TO: Water Rights Section May 15 1997
FROM: Groundwater/Hydrology Section Michael Zwart
SUBJECT: Application G-14507
Reviewer's Name

Subject: APPLICATION G-14507, NANCY A. PROCTOR; EMPRISE, INC.

Wells in the vicinity of application G 14507

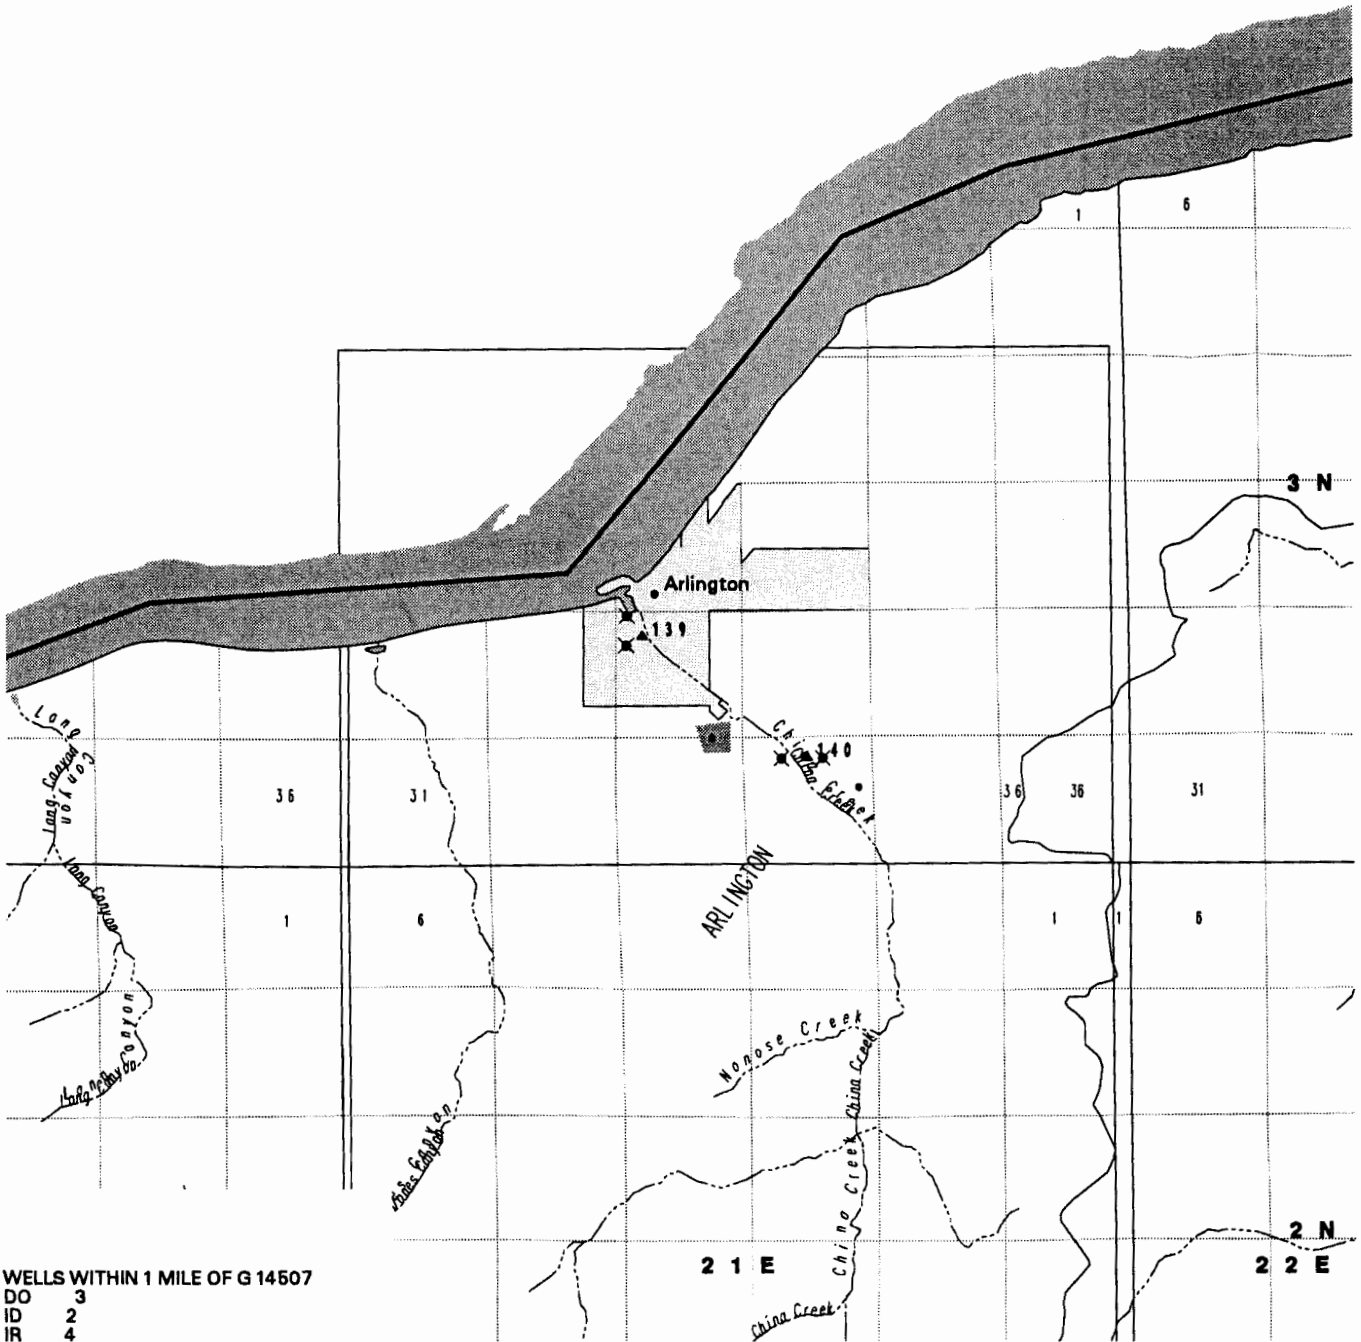
This application proposes to appropriate about 300 gpm from a well for quasi-municipal use. The well is 245 feet deep and penetrates a confined aquifer developed in basalts of the Columbia River Basalt Group below a depth of 80 feet. The well is about 50 feet from China Creek and about 6700 feet from the Columbia River. There is no potential for substantial interference with surface water sources, based on the confined aquifer penetrated.

The well construction likely is subject to Oregon Health Division administrative rules (OAR 333, Chapter 061), because of the type of proposed use. The information given on Form Q implies that the well may be used by the City of Arlington as an emergency backup. This is not clear in the application, unless the area of use for emergency backup is coincident with the area for quasi-municipal use. I recommend that the well construction issue be referred to Enforcement staff.

I recommend permit conditions 7A and 7B.
